NOTICE OF PROPOSED DEVELOPMENT

NO:	SD 2184
LOCATION:	683 & 673 Deep Creek Road WYNYARD
APPLICANT:	CLTP Panel Products
SCHEME:	Tasmanian Planning Scheme – Waratah-Wynyard
ZONING:	Rural
USE CLASS:	N/A
PROPOSAL:	Subdivision (Boundary Reconfiguration (2 into 2 lots))
DISCRETIONARY MATTER:	Lot design 20.5.1 (P1)

Additional Information Response
673-683 Deep Creek Road, Wynyard

DRAWING
SITE PLAN
 JOB NO. 23608
 DWG NO. A100
 REV.

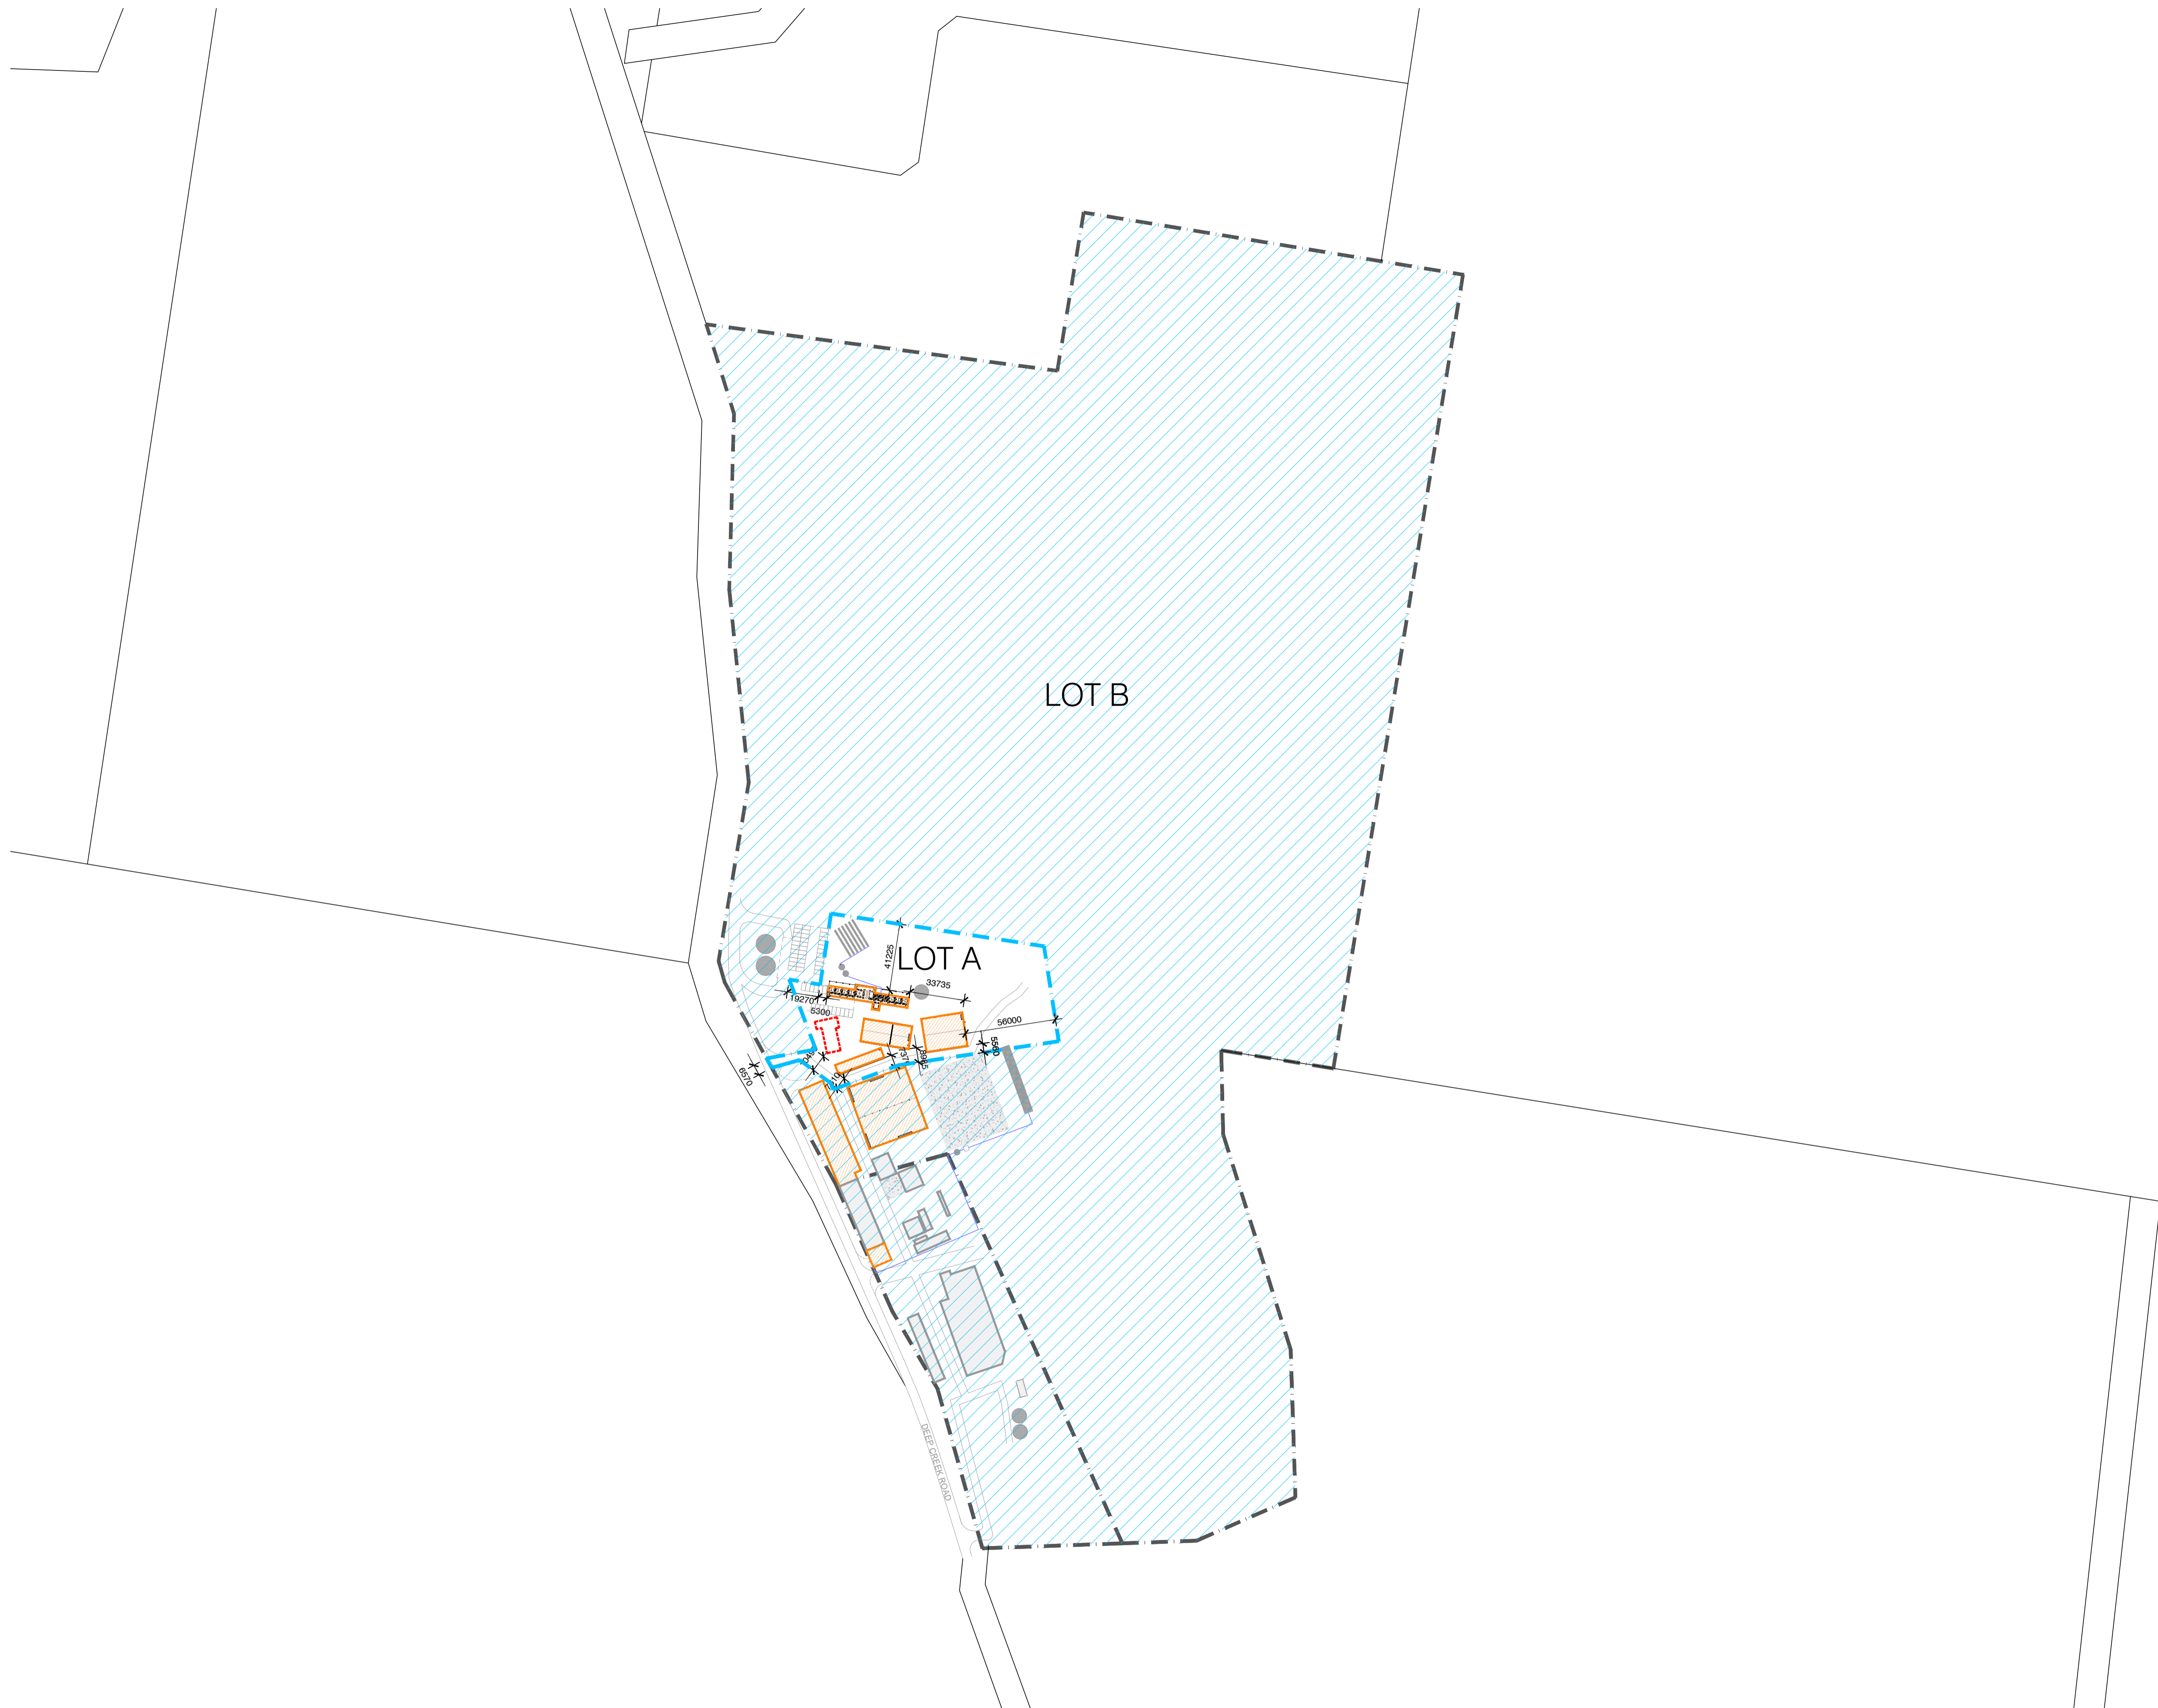
Demonstration of compliance with Clause C2.5.4 (A1/P1) Loading bays of the Parking and Sustainable Transport Code provisions. It requires a plan showing the arrangement of loading bay on proposed Lot A and Lot B.

If the proposal includes a construction of new parking area, it requires demonstration of compliance with Clause C2.6.1 (A1/P1) & C2.6.2 (A1.1/P1) of the Parking and Sustainable Transport Code provisions. Onsite there appears to be parking forming to the east of the approved water tanks near the frontage. I attach a picture for your records. Is this a temporary arrangement? If not, these spaces will require a permit and it is recommended they be included within the application.

The proposed site plan, current site arrangements and previously issued planning permits have buildings of different locations and sizes. Please provide an up-to-date site plan for consistency. This may be easiest with a site plan showing all the existing and proposed buildings onsite after development, similar to the site plan of the most recent approved development application.

There is ample area for loading and unloading within the large format sheds provided within both lots. Likewise, the hardstand areas that surround the buildings in both lots are sufficiently dimensioned to functionally accommodate loading.

The current location is a temporary arrangement. The updated plan submitted as part of this application provides the proposed location of the car parking areas within both Lot A and Lot B. It is understood that an amendment to the existing permit approvals may be required to update the locations of the car parking areas.

The project architect visited the site last week and has corrected the site plan to reflect the as-constructed conditions. This arrangement is now included as the base layer to the enclosed revised subdivision plan. It is acknowledged that these corrections may require a minor amendment to the existing approvals. It is requested that this be managed separately in due course.
